Addendum 3 for RFB927940-04

Project Name: WRC Decentralization Phase 4 & Fire Alarm Phase 3 (9279.40 & 9279.41) Bid Issuance #4
DAS RFB #: 927940-04
DAS Project #: 9279.40 & 9279.41
Date: 6/2/2026

A6 SECOND FLOOR THERMOSTAT PLAN
1/16" = 1'-0" 0" 24'

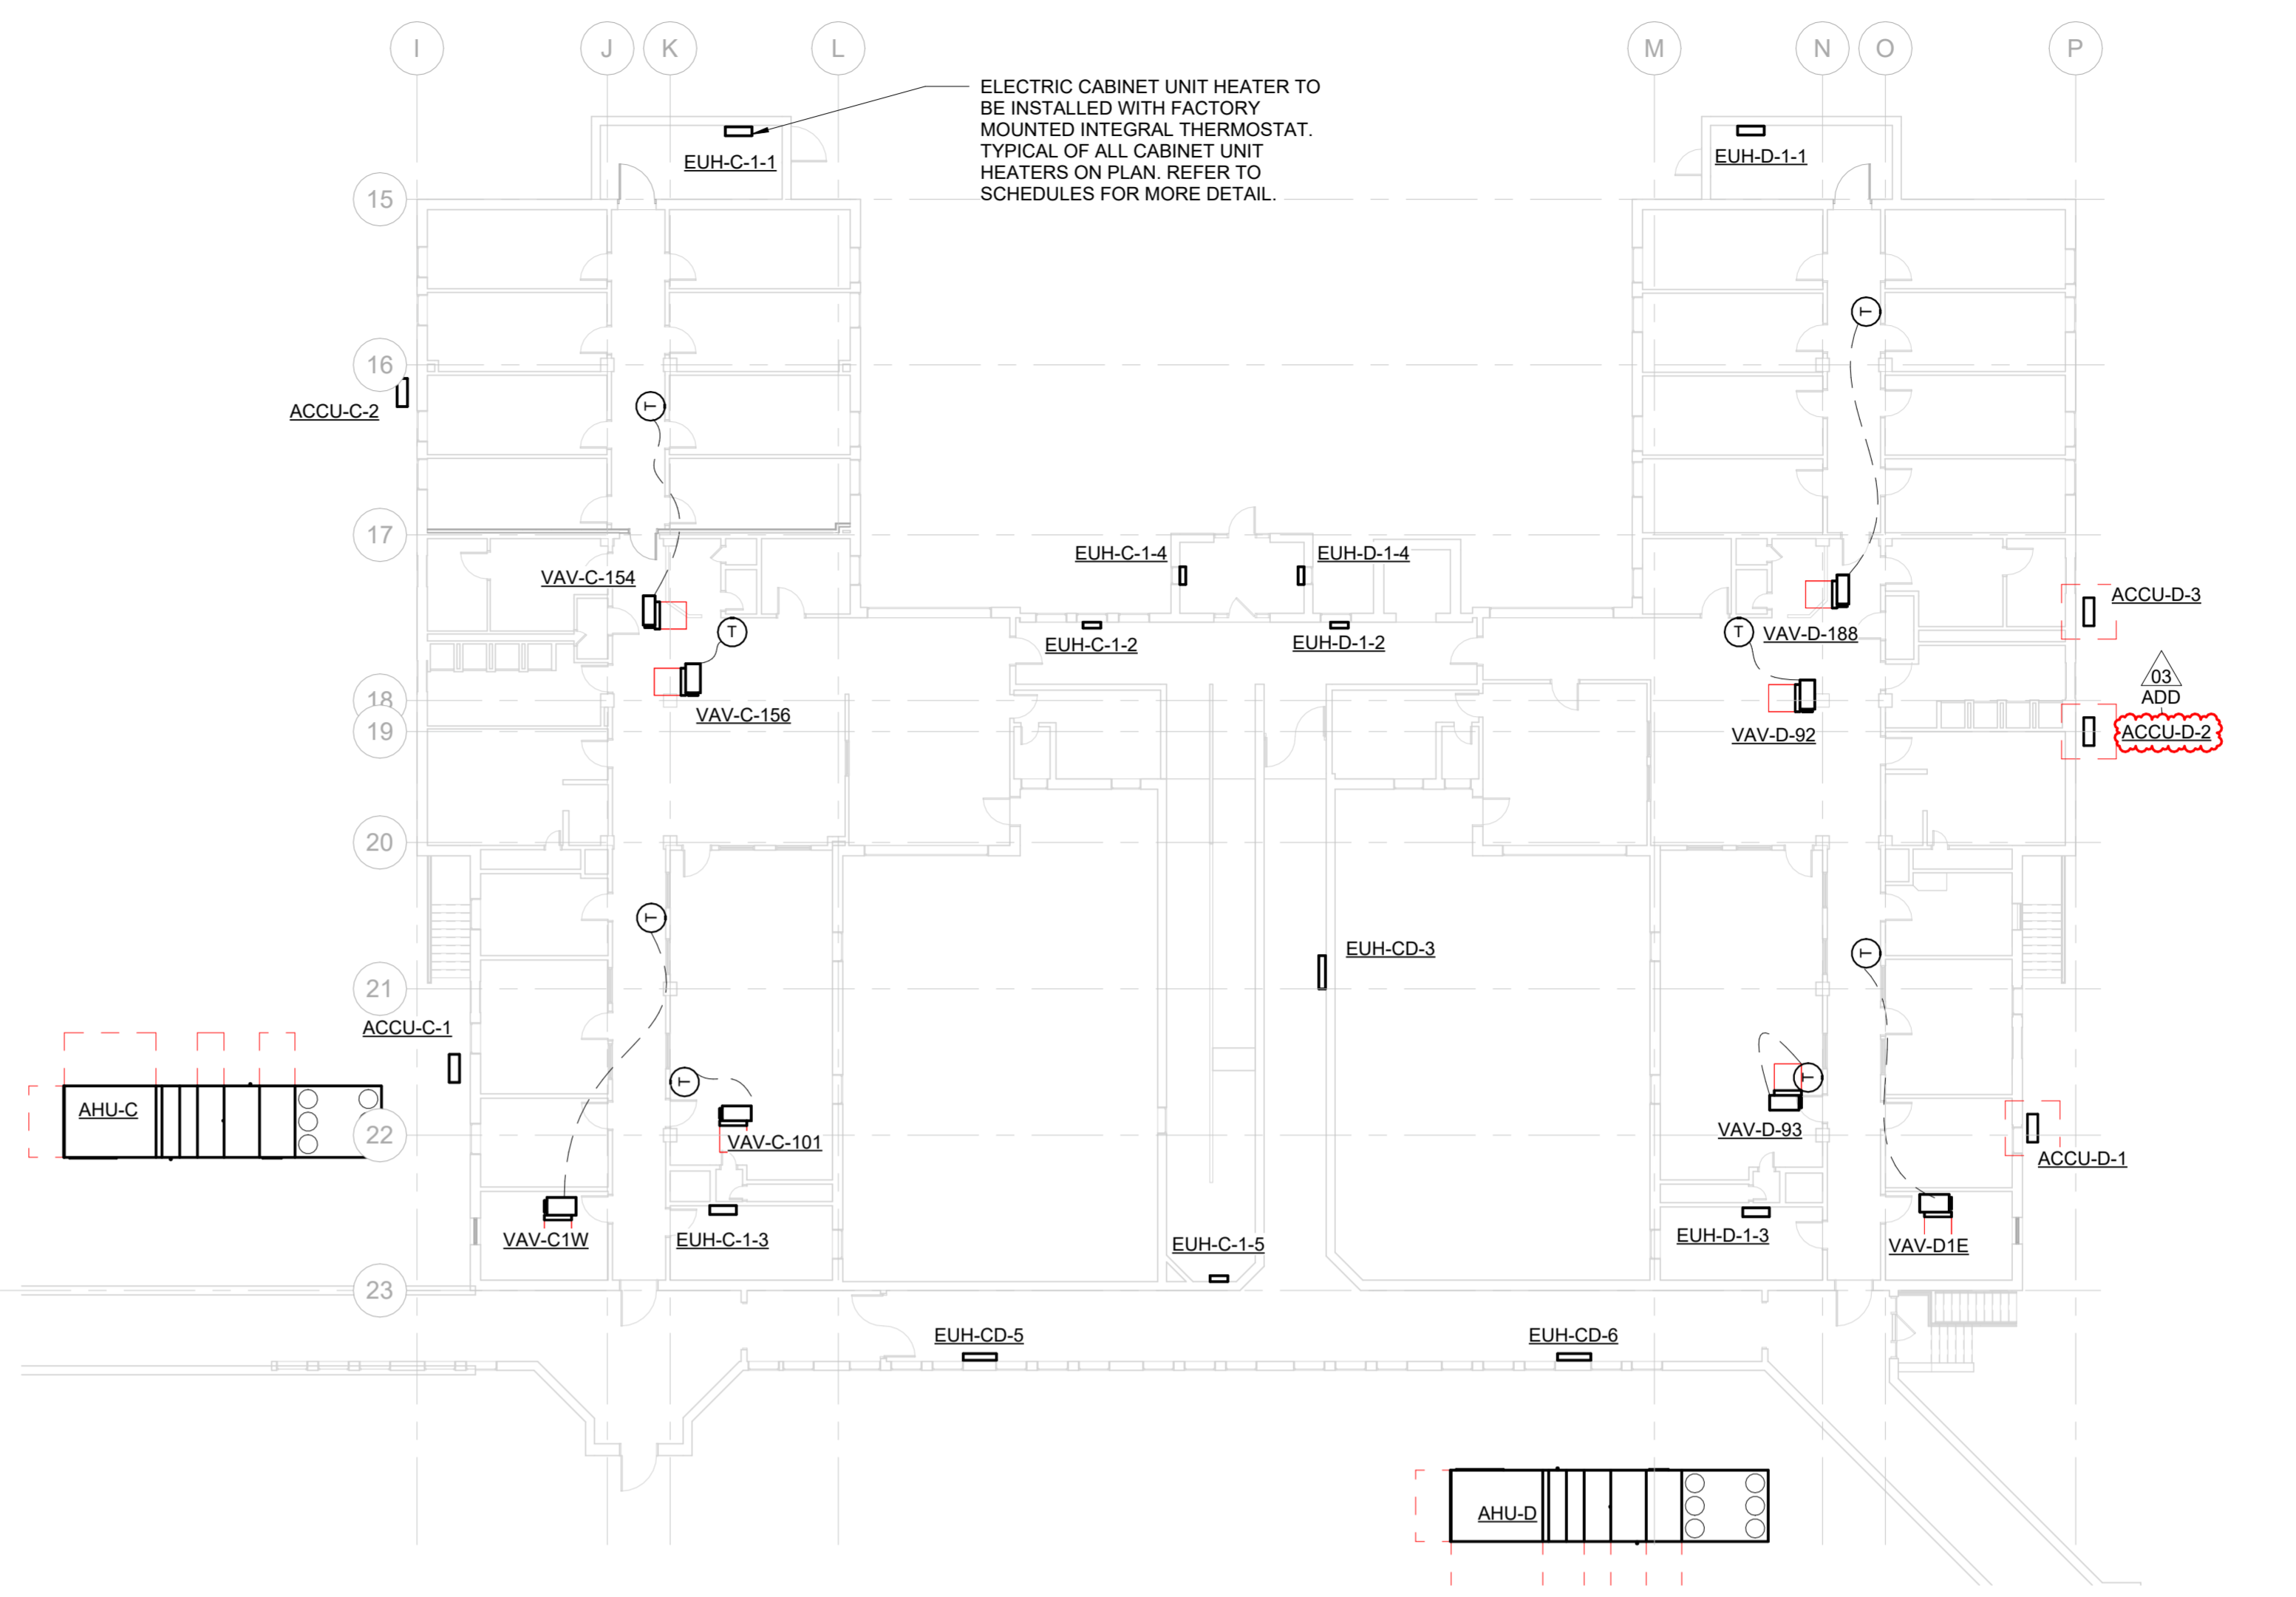
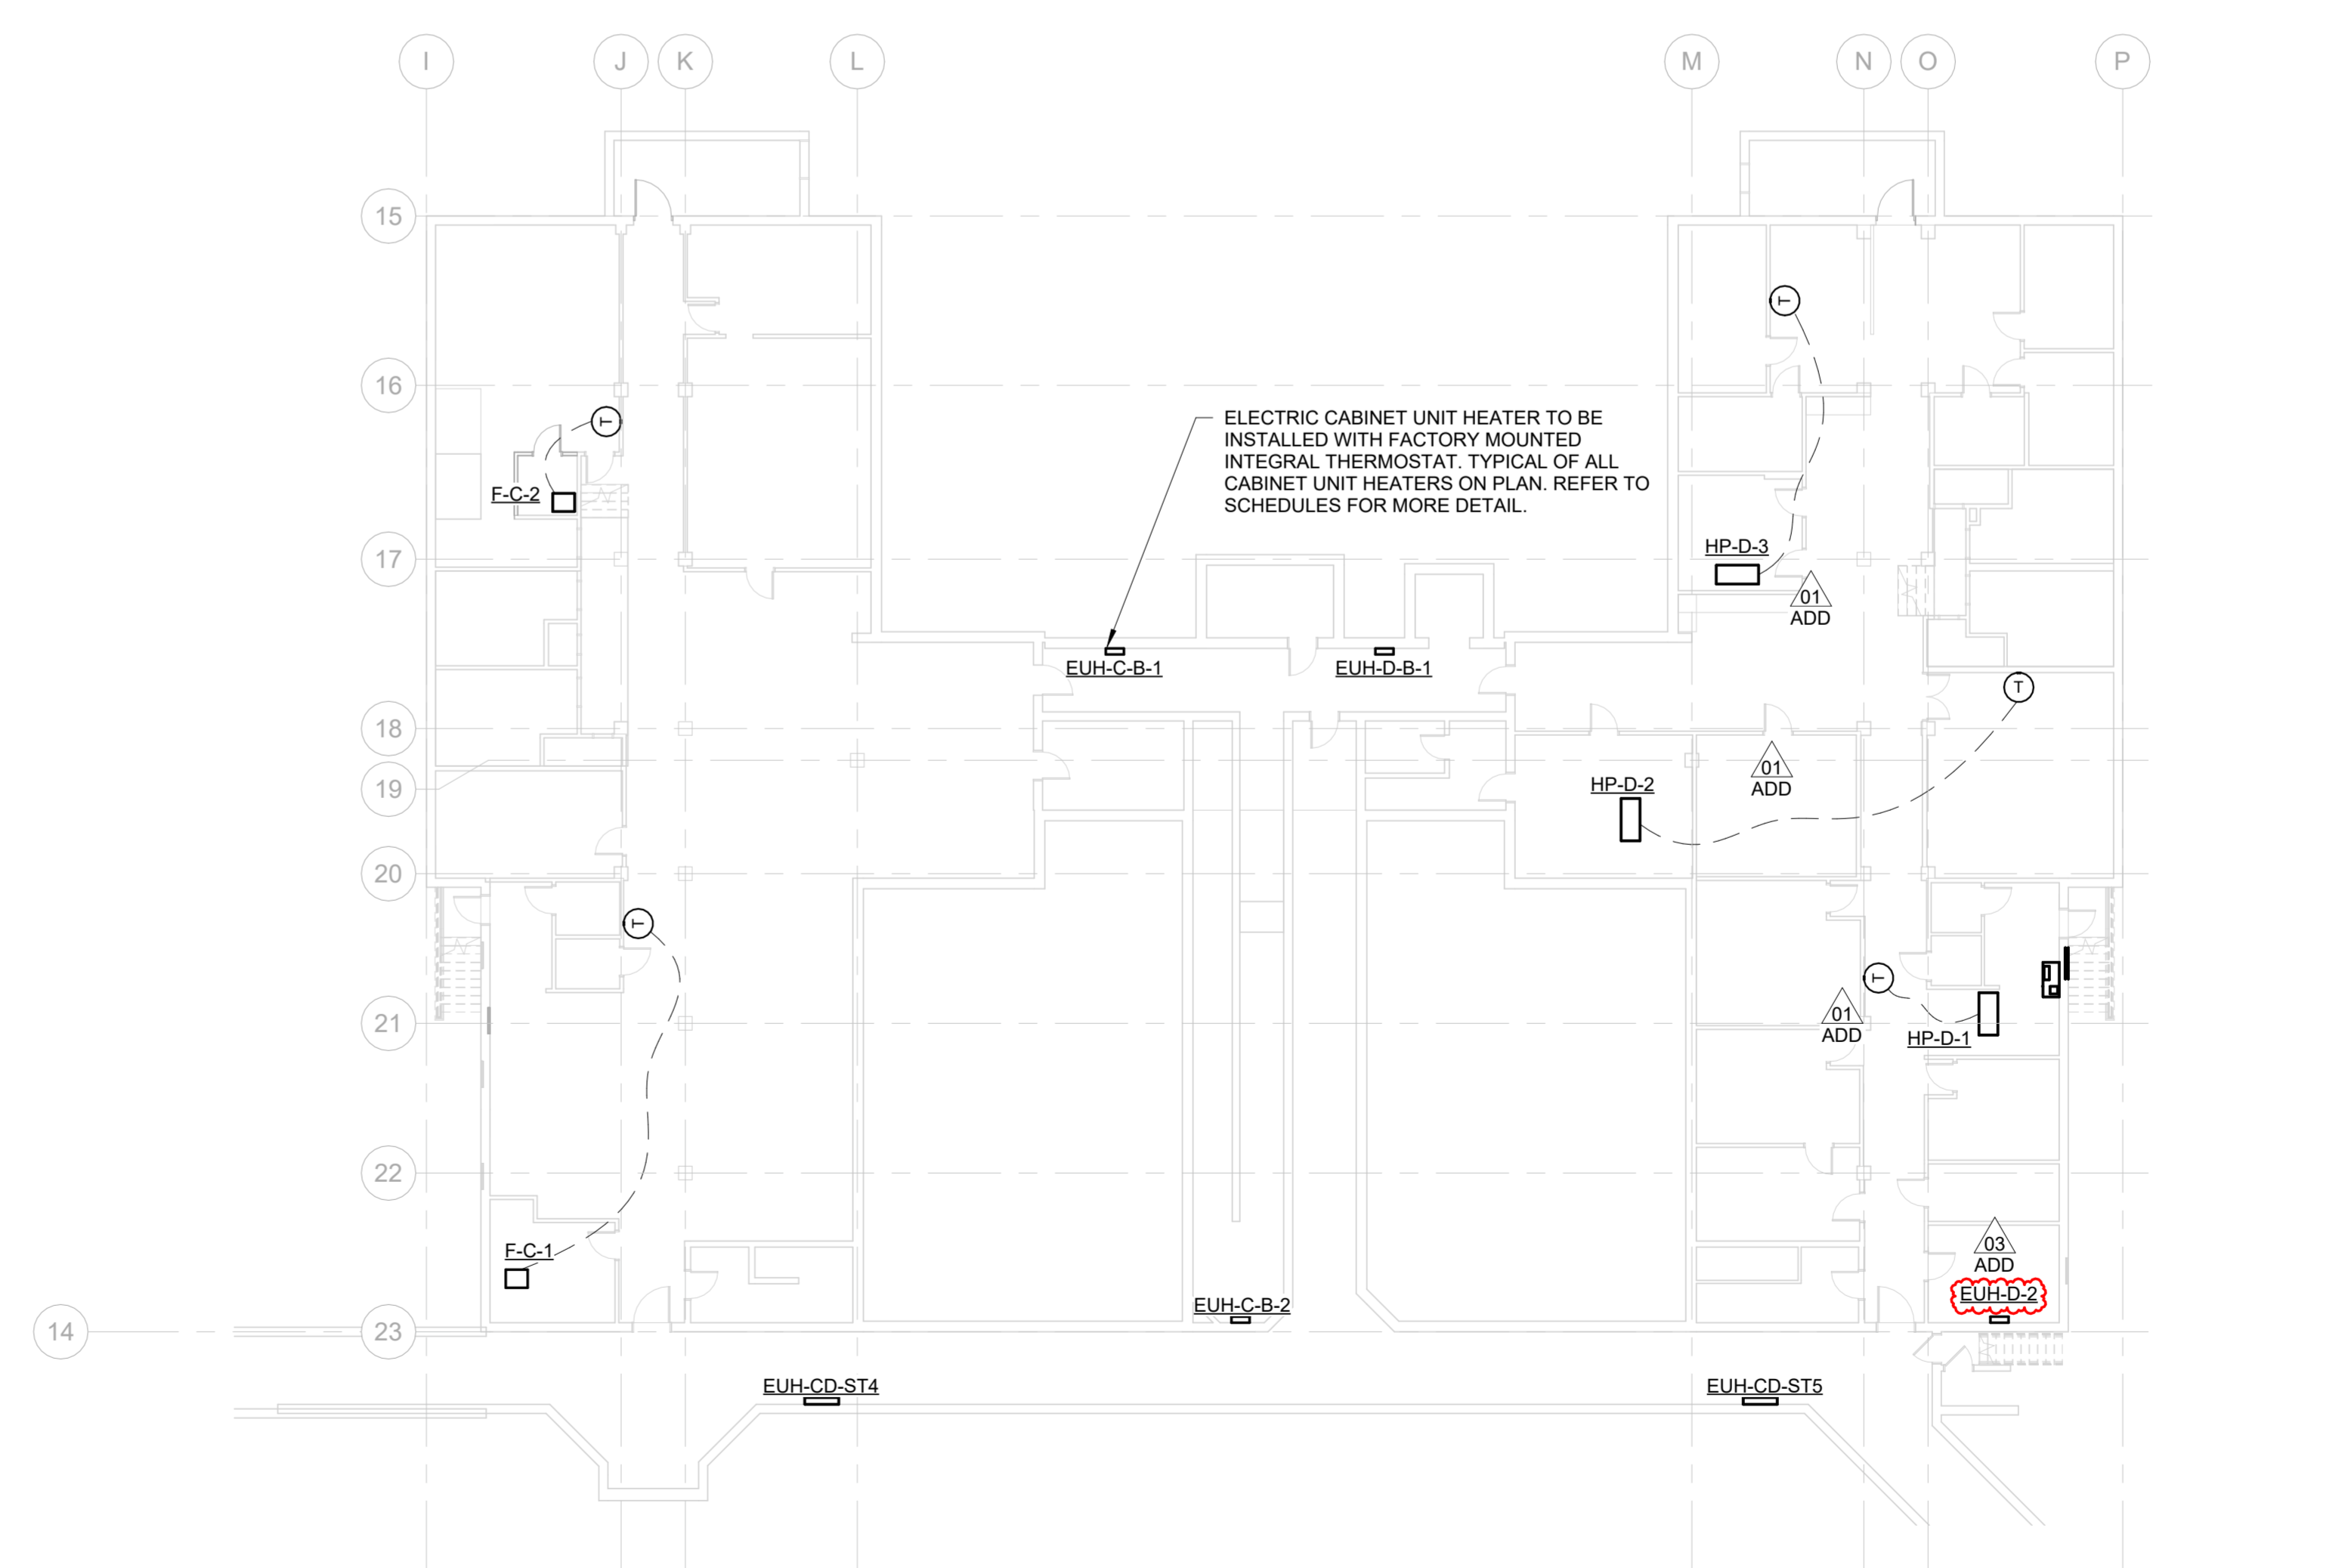
- **13-M300 – THERMOSTAT PLAN:**
 - **ADD** Tags to EUH-D-2 and ACCU-D-2.
- **13-M400 – BUILDING C & D ENLARGED AHU PLANS:**
 - **ADD** Approximate duct support locations to exterior ductwork and associated note “SUPPORTS REPRESENTATIVE OF APPROXIMATE REQUIRED SUPPORTING DISTANCE REQUIREMENTS AND QUANTITY. CONTRACTOR SHALL VERIFY SUPPORTING REQUIREMENTS WITH FINAL DUCT SIZES AND SMACNA GUIDELINES. CONTRACTOR SHALL COORDINATE LOCATIONS OF SUPPORTS WITH ALL UNDERGROUND UTILITIES AND VERIFY ALL EXISTING CONDITIONS PRIOR TO EXCAVATION AND CONSTRUCTION.”
